COPLEY TOWNSHIP ROTHROCK ROAD MUCD FINAL DEVELOPMENT PLAN PHASE 1 MAJOR SITE PLAN STAFF REPORT

February 3, 2022

APPLICANT SUMMARY FINAL DEVELOPMENT PLAN

THREE PHASE PLANNED DEVELOPMENT

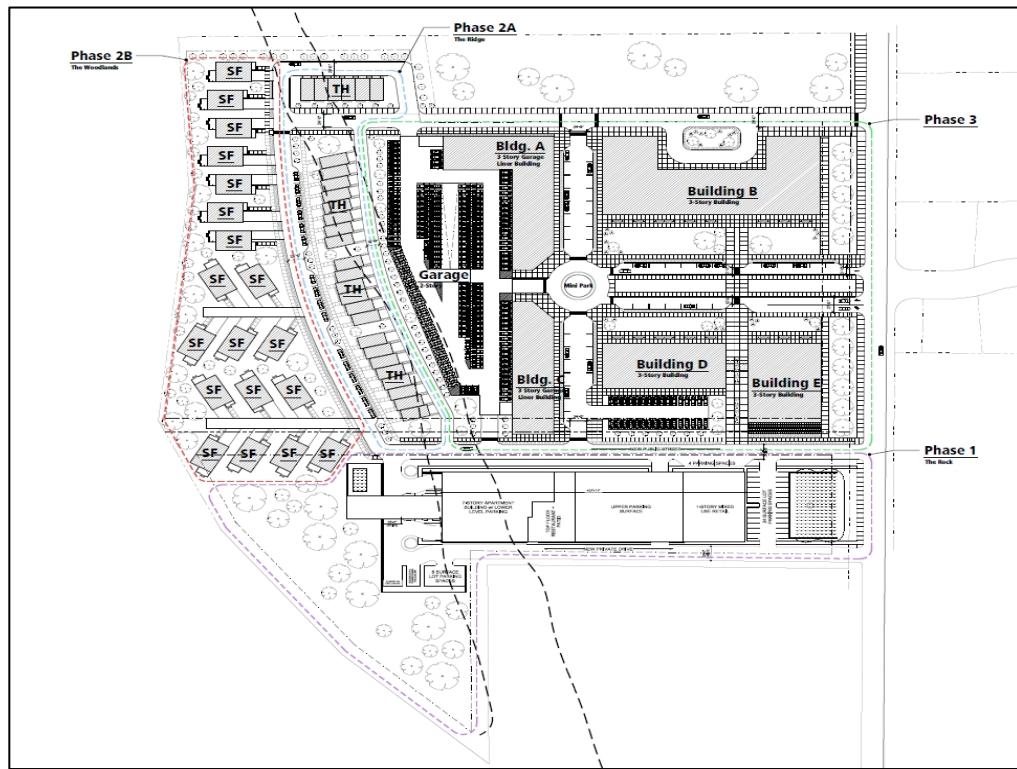
2. Permit, in these areas, a pedestrian oriented mixture of uses including civic uses, offices, limited retail, and higher density residential in a manner that reinforces existing compact development. **THE GENERAL DEVELOPMENT PLAN CALLS FOR A MIX OF HIGHER DENSITY RESIDENTIAL AND LIMITED RETAIL. THE PLAN CALLS FOR OPEN PARKLAND. RECOMMEND INCLUSION OF TRAIL SYSTEM AND/OR SHARED USE PATH NORTH AND SOUTH TO PERMIT CONNECTIVITY TO THE MONTROSE RETAIL CENTER AND THE ROTHROCK ROAD ROUND A BOUT.**

c. Connections to community facilities, offices and retail centers within and adjacent to the MUCD District. **RECOMMEND INCLUSION OF TRAIL SYSTEM AND/OR SHARED USE PATH NORTH AND SOUTH TO PERMIT CONNECTIVITY TO THE MONTROSE RETAIL CENTER AND THE ROTHROCK ROAD ROUND A BOUT.**

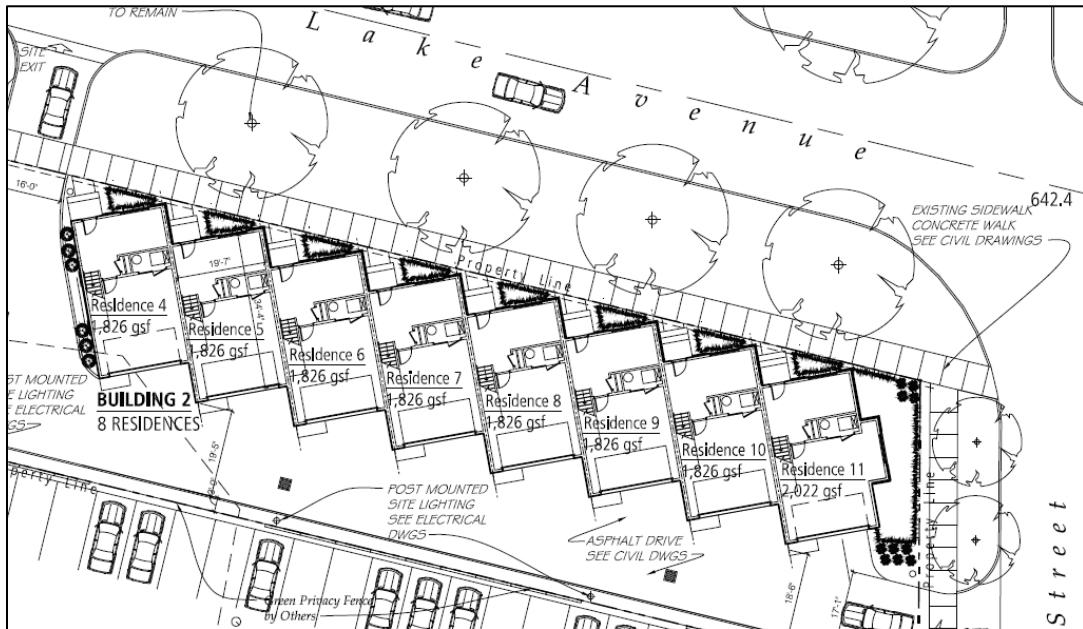
THE PLAN CALLS FOR 8 ATTACHED TOWNHOME BUILDINGS. RECOMMEND APPROVAL. SEE SAMPLE CONSTRUCTION OF PROPOSED 8 UNIT BUILDING BELOW:

ACCESSORY SCREEING AND OPEN SPACE REPLANTING

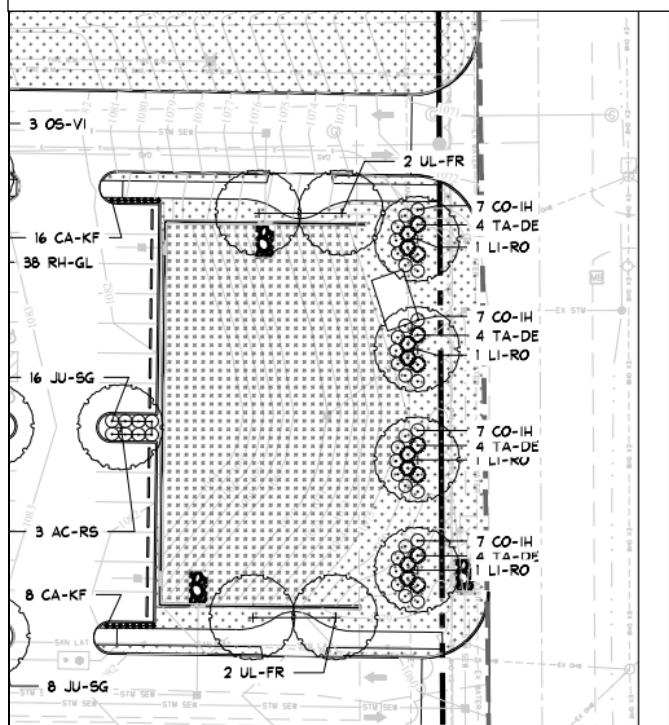
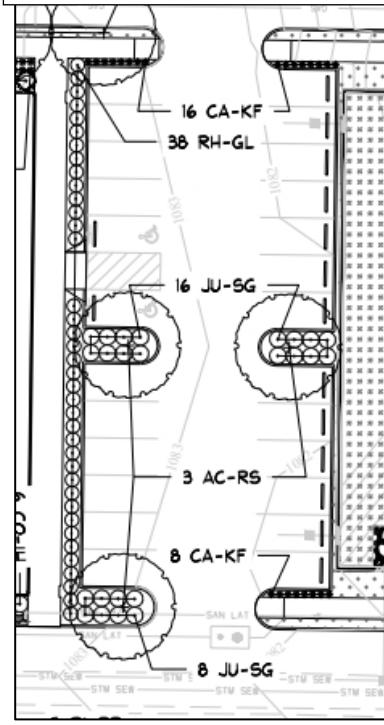
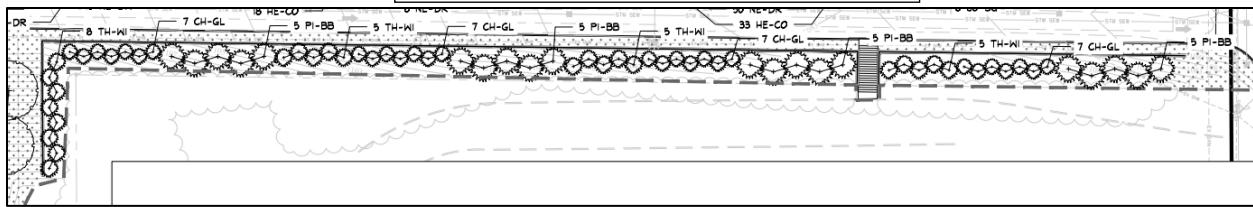
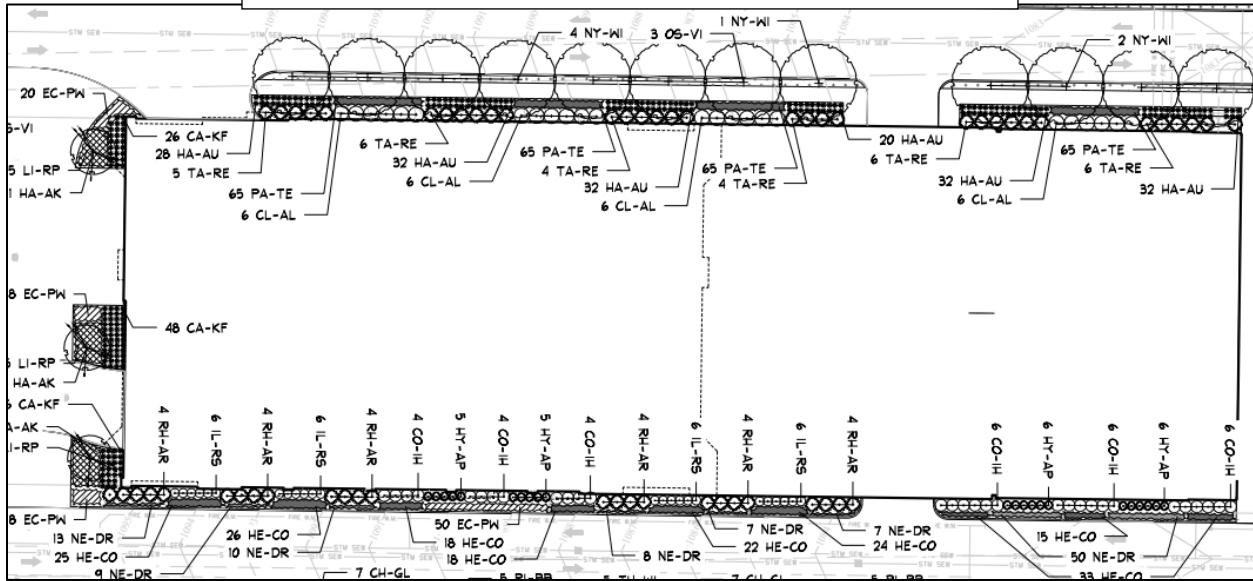
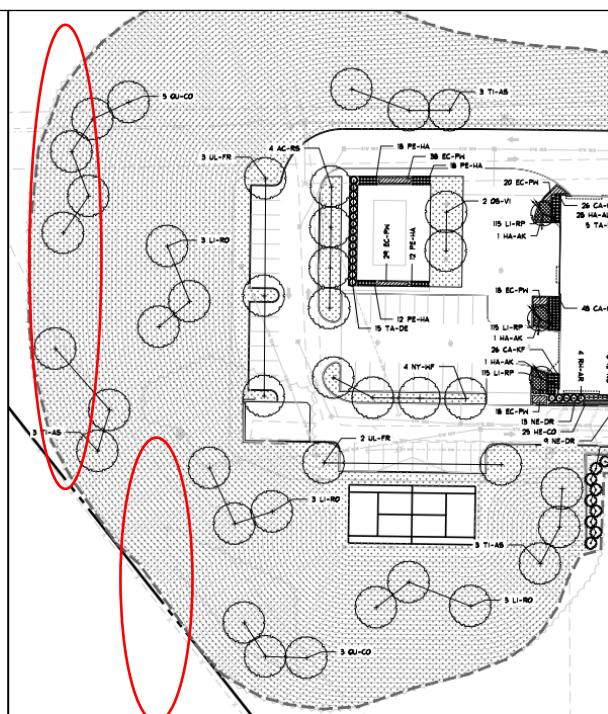
RECOMMENDTION: ADDITION OF FULL EVERGREEN SCREEN BUFFER ALONG THE WESTERN PORTION OF PHASE 1

TREE PRESERVATION PLAN

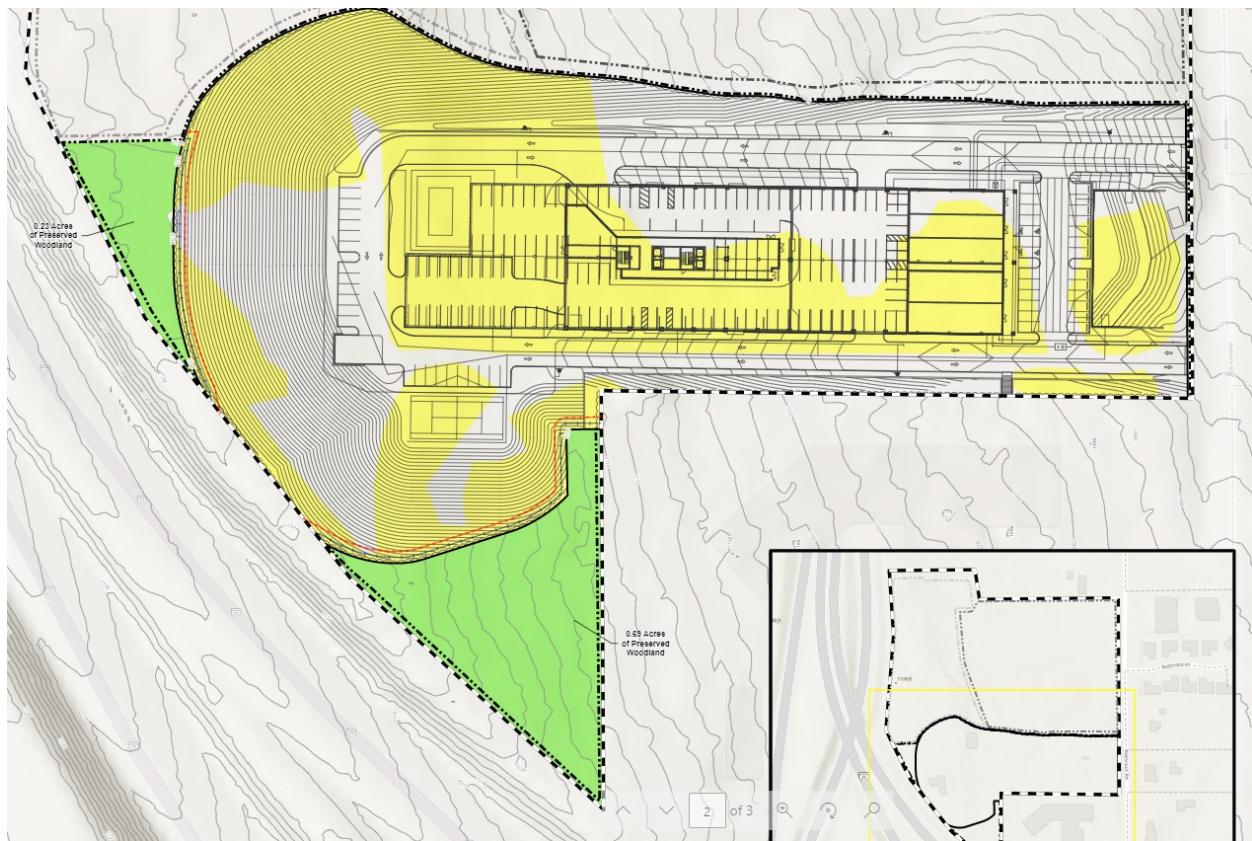
The applicant will include a Tree Preservation Plan in the full construction set drawings. The plan will identify the following requirements as found in Article 16, Section 16.05:

RECOMMENDATION: Approval of Tree Assessment and Fee In Lieu of plan for removal. Approval of tree clearing for Phase 1 Limits of Disturbance in advance of the Zoning Certificate conditioned upon approval from Summit Soil & Water Conservation District and express approval by property owner for Parcel 1501804.
